### Re: 49 CFR Part 573; Recall of Mercedes-Benz R-Class (251) Starter Wiring Harness

Re: Update Recall Campaign 2006 040002 - Starter Wiring Harness, Model 251 MY 2006

#### The Recall Campaign Bulletin for this campaign has been revised.

Campaign No. 2006040002, July 2006

Figure 3

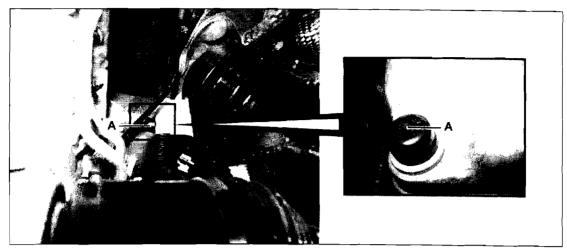
An additional protective cap will now be installed on the rear engine support mounting screw. Vehicles previously repaired under this campaign do not need this cap installed.

3. Install protective cap on rear engine support mounting screw (A, Figure 3).
